Re: Draft Environmental Impact Report for the South Bay Substation Relocation Project, Chula Vista, California

The San Diego National Wildlife Refuge Complex (Complex) has reviewed the draft Environmental Impact Report (EIR) for the South Bay Substation Relocation Project located in Chula Vista, California. We offer the following comments for your consideration.

Figure 2 CNDDDB Corrected Occurrences Map

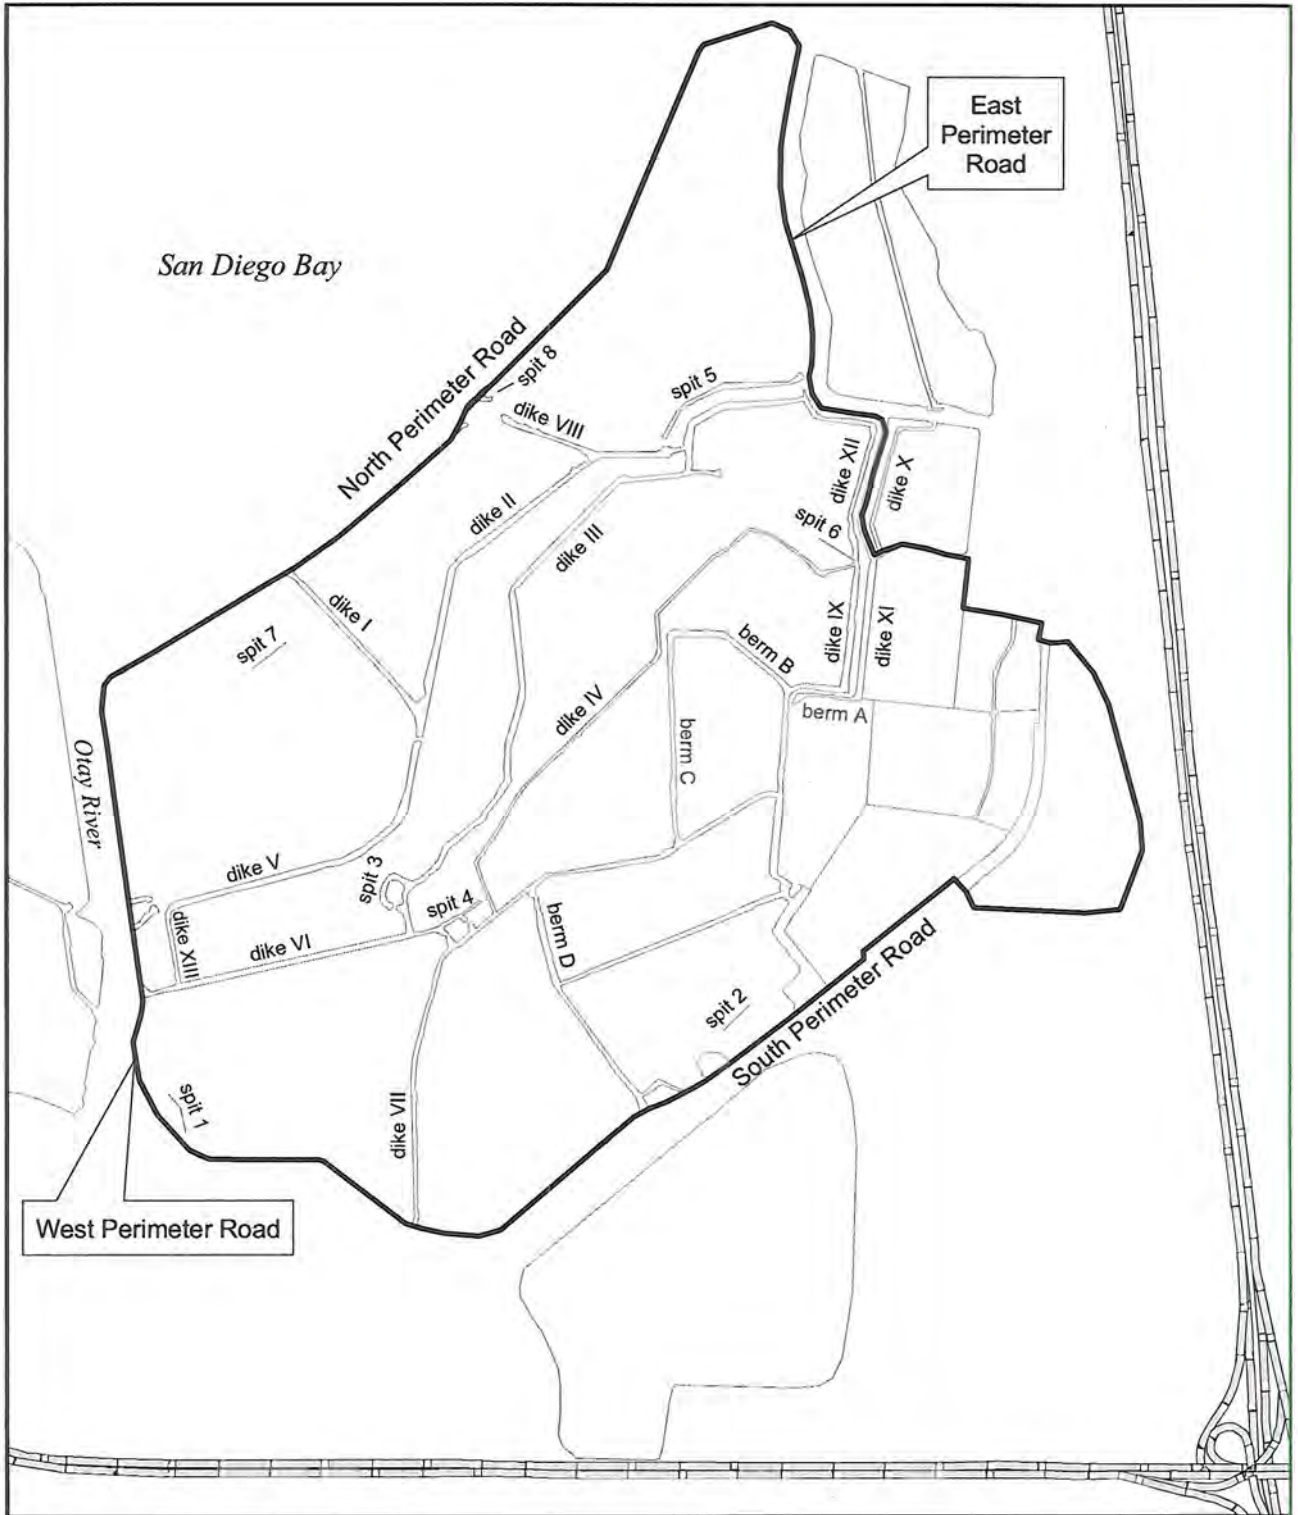
3. In the near future when the salt ponds are restored to intertidal habitat (See Figure 2), disturbances and night lighting associated with the proposed facility could affect a variety of migratory birds that inhabit nearby areas. These migratory birds include a number of species identified by the Department and the Service as Species of Special Concern and Birds of Conservation Concern, respectively. The Department recommends that the DEIR discuss specifically the effect of noise and lighting on avian species associated with the salt ponds. This discussion should include recommendations based on construction and ongoing operational noise and lighting at the proposed facility and evaluate these impacts

Figure A-1: Bayfront Enhancement
Alternative Overhead Alignment Map 3 of 9

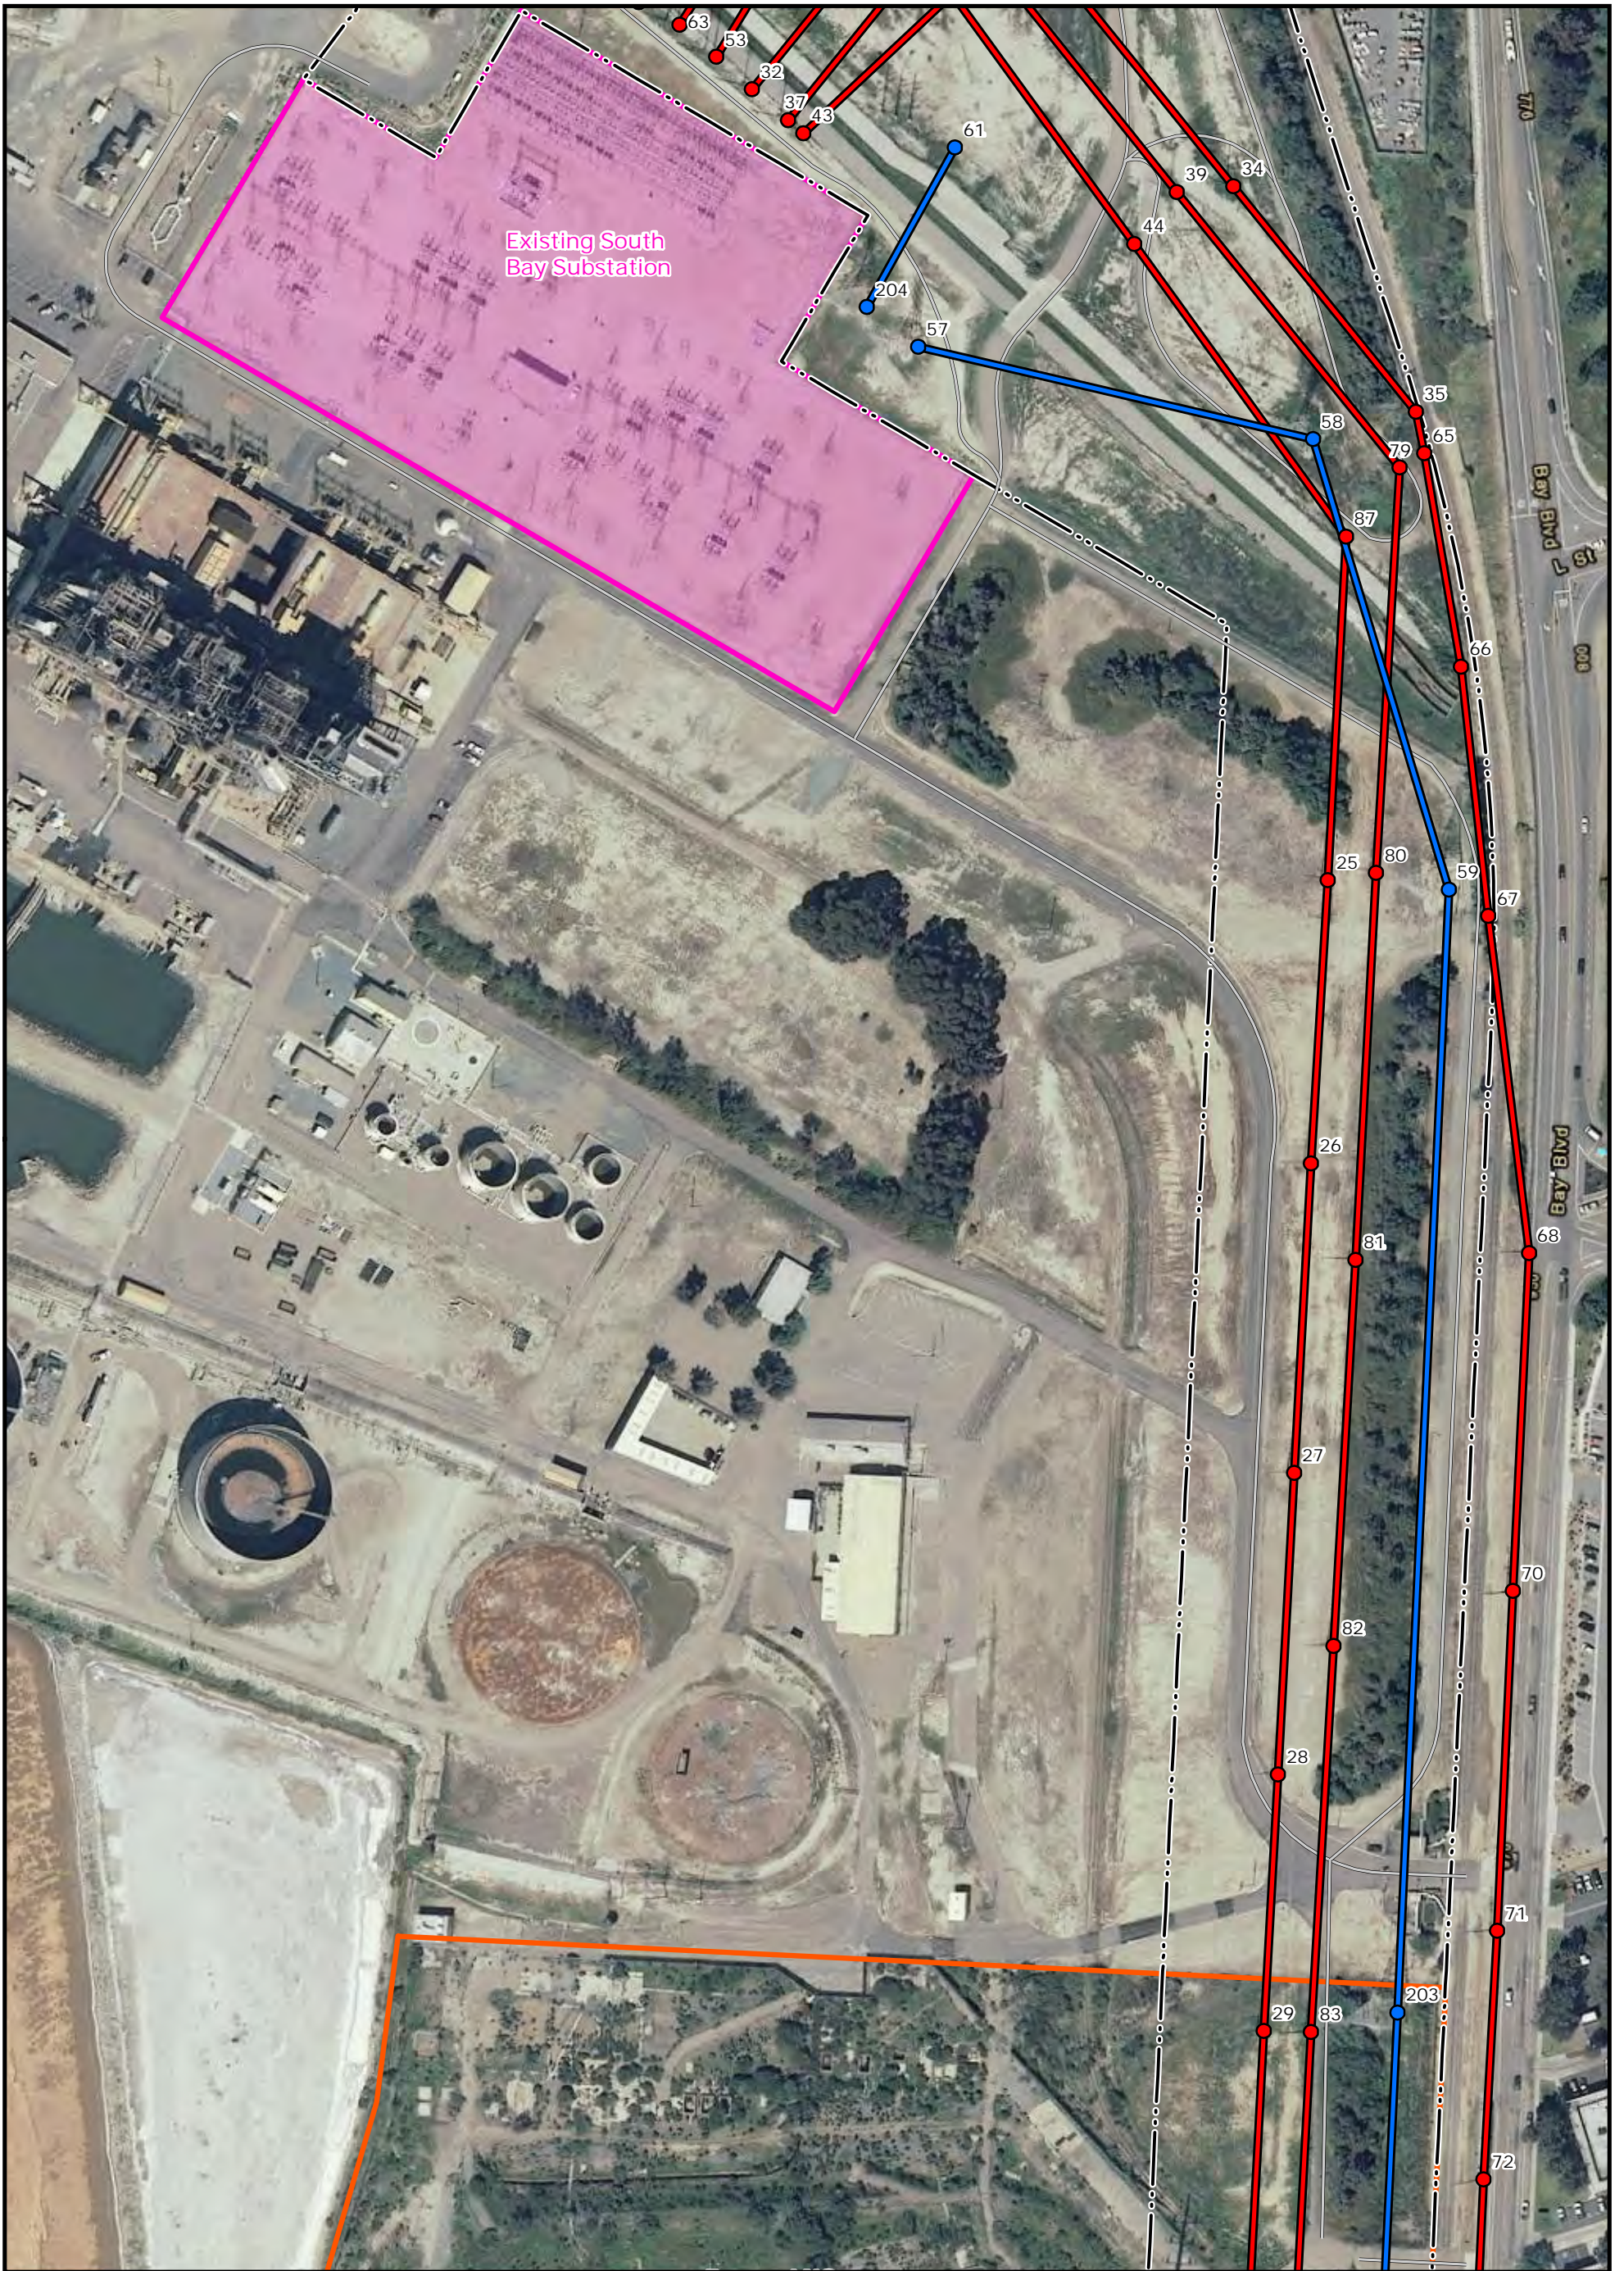
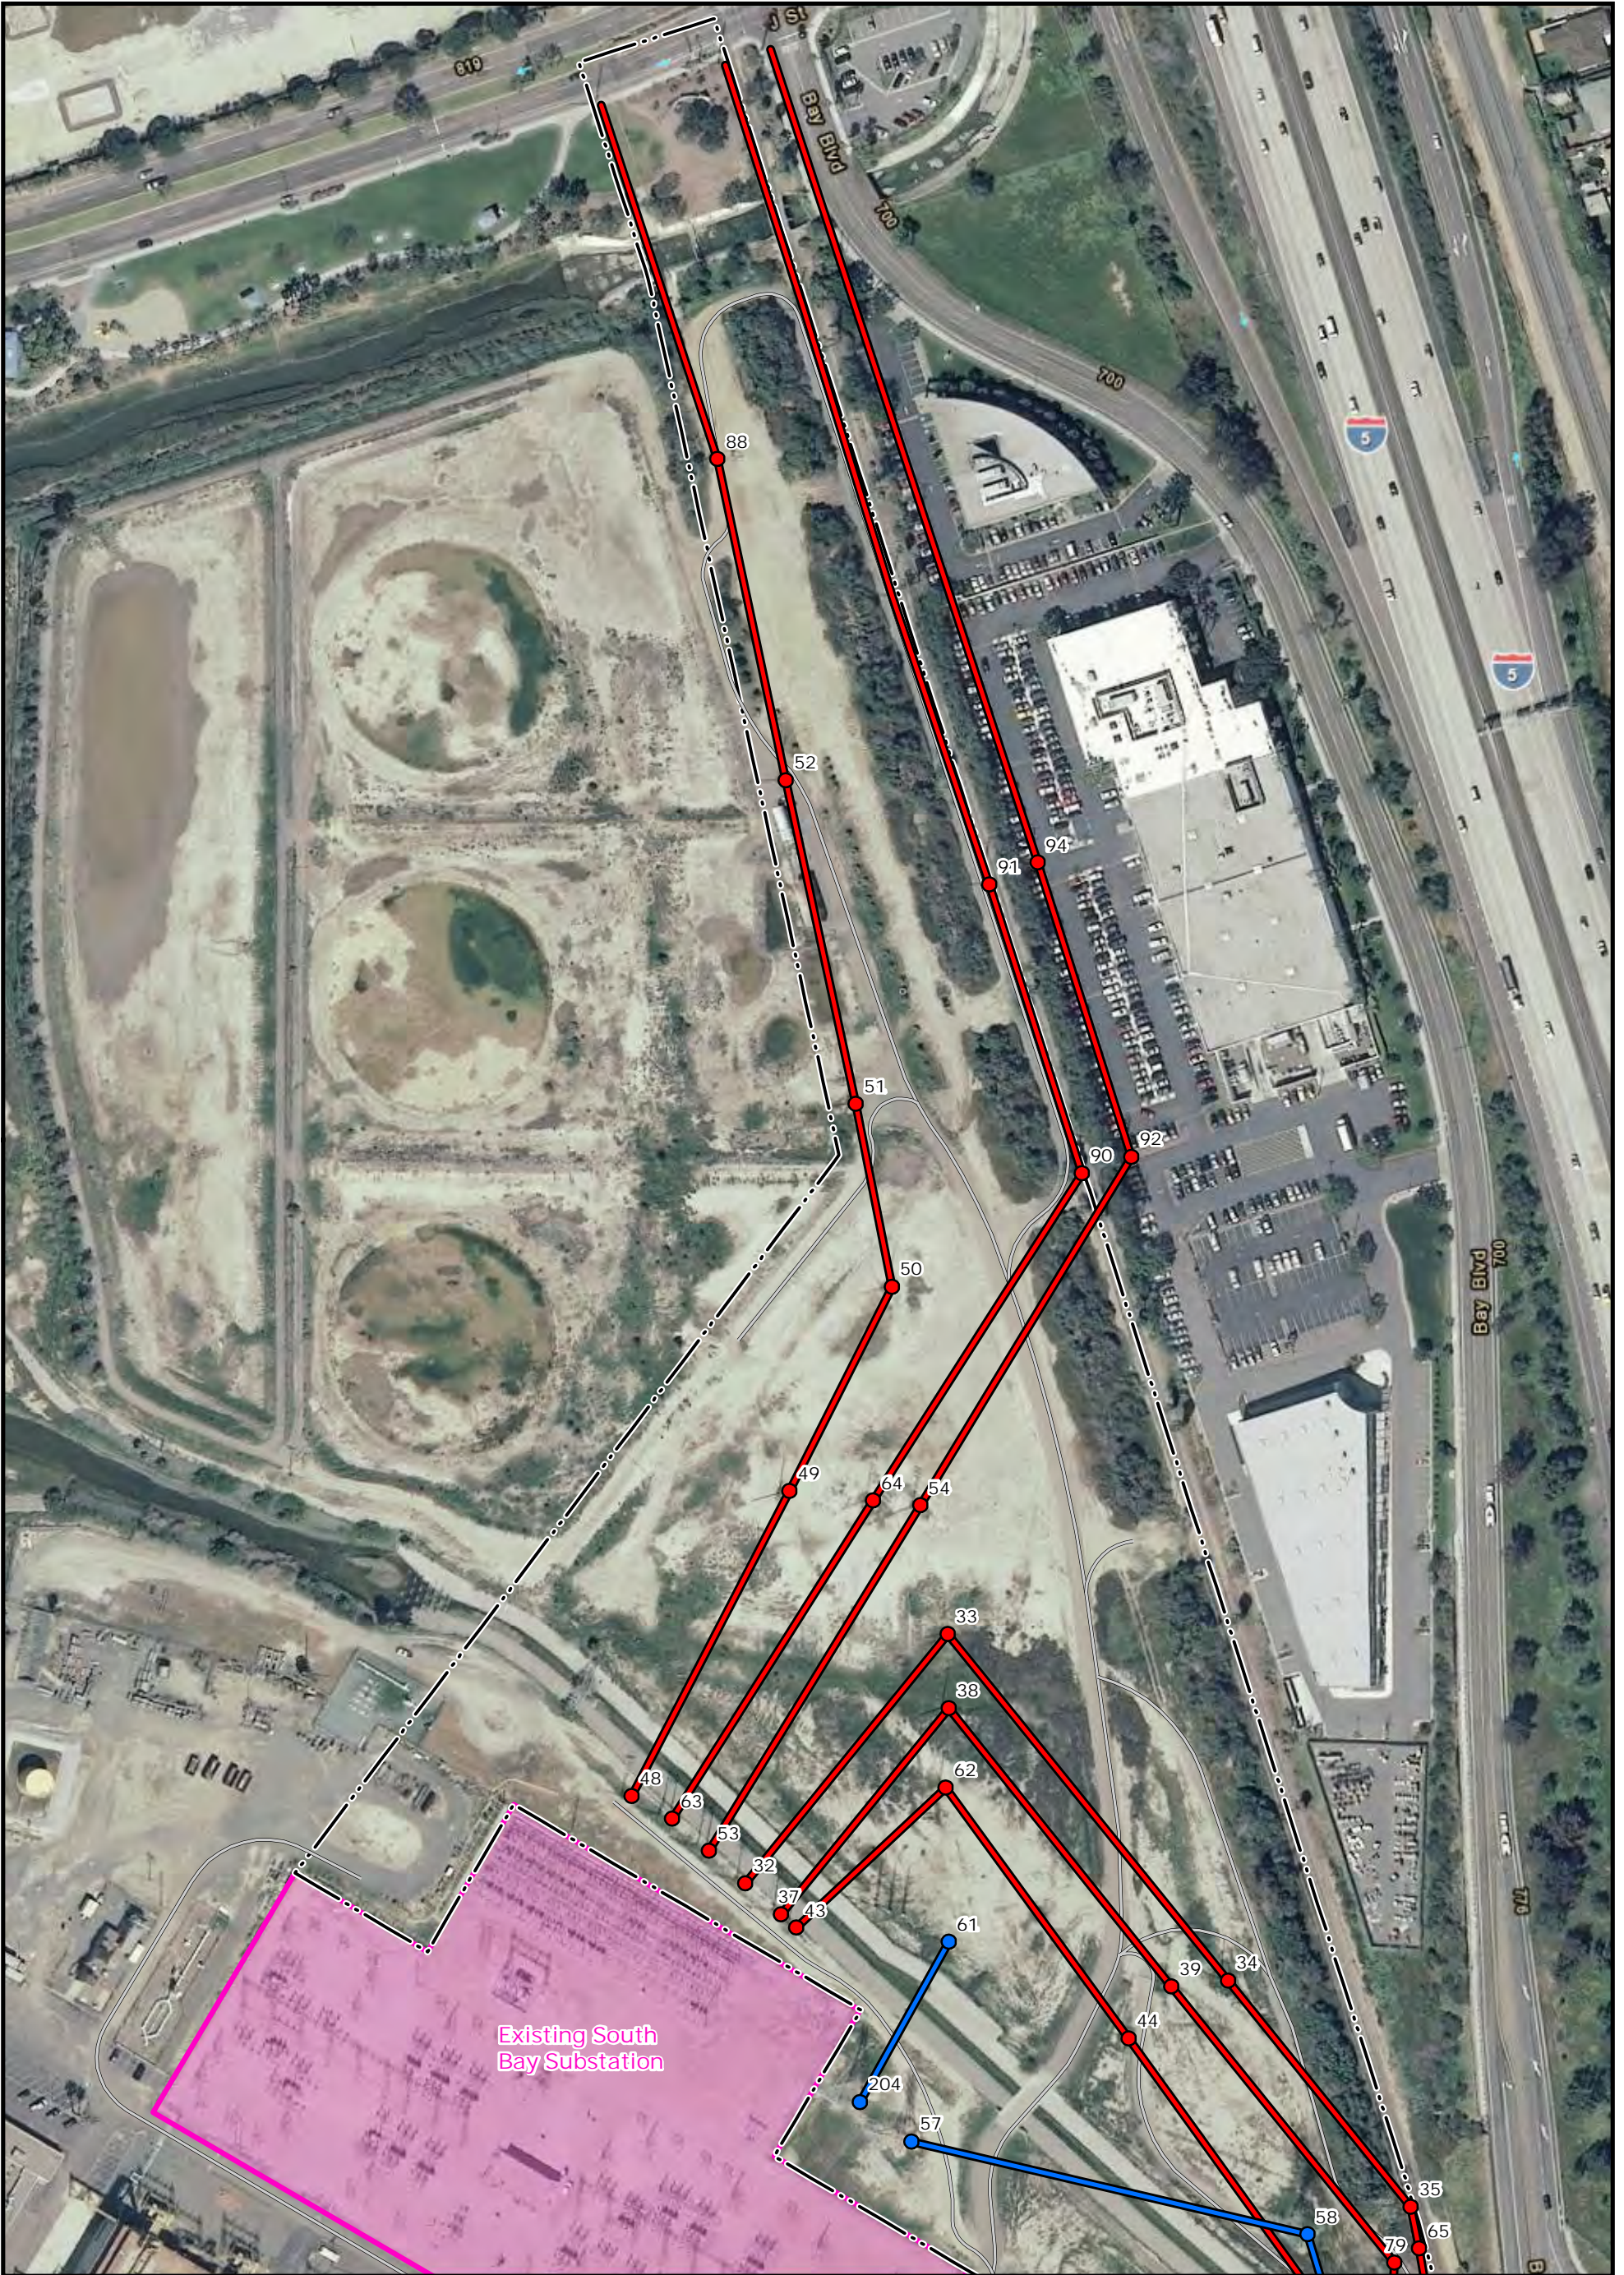
- Removal of two, approximately 110-foot-tall 138 kV steel lattice towers (188700 and 188701). As shown in Figure A-1: Existing Overhead Alignment Map 1 of 9 and Bayfront Enhancement Alternative Overhead Alignment Map 3 of 9 in Attachment A: Figures, one tower is located west of Bay Boulevard and one tower is located within an existing parking lot east of Bay Boulevard.

Like the undergrounding that is already included in the Proposed Project, the removal of these two lattice towers and associated facilities would generate significant visual benefits, consistent with California Coastal Act Chapter 3 policies regarding the restoration and enhancement of visual resources, particularly within visually degraded areas. The facilities to be removed and the resulting environmental benefits are depicted visually in Figure A-1: Overhead Alignment Map and Figure A-2: Overhead 138/230 kV Facilities Schematic in Attachment A: Figures. Figure A-1: Bayfront Enhancement Alternative Overhead Alignment Map 3 of 9 in Attachment A: Figures depicts facilities that will be
